Architectural Review Board November 28, 2018

18-069INF – DUBLIN ARTS COUNCIL PLAZA

Request for informal review and feedback for landscaping and site improvements for the Dublin Arts Council entry plaza.

3. Site Plan

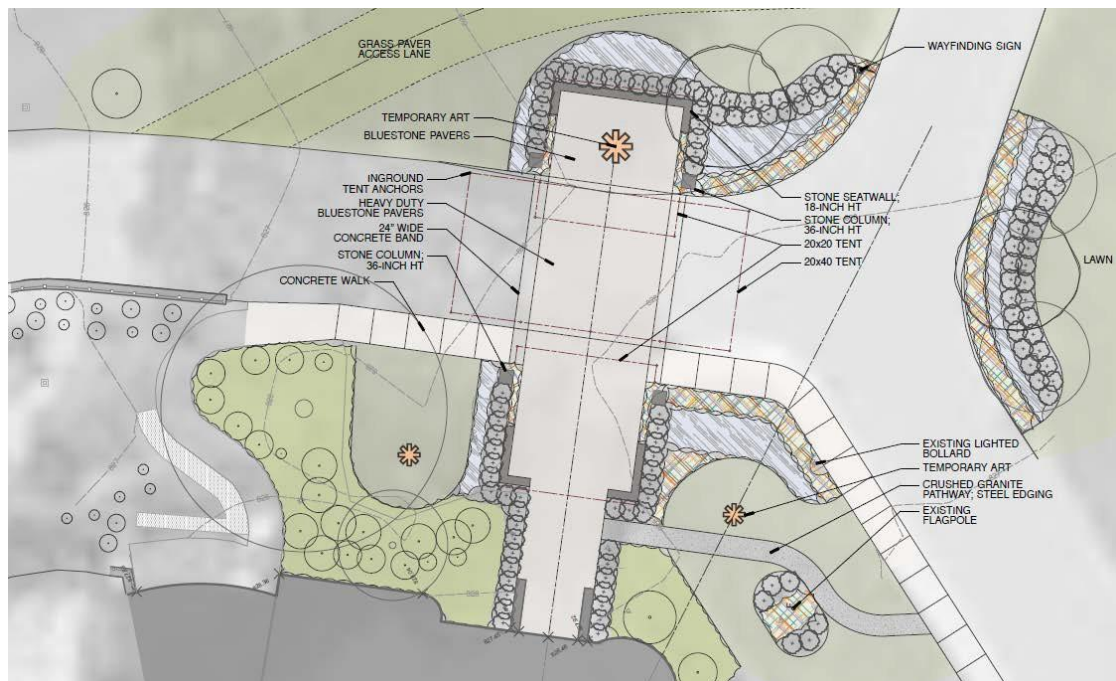
- 1) Are the proposed improvements complementary to the historic structure?
- 2) Are the proposed materials and plant selections appropriate?
- 3) Are the vehicular use areas addressed in a sensitive manner?
- 4) Other considerations by the Board.
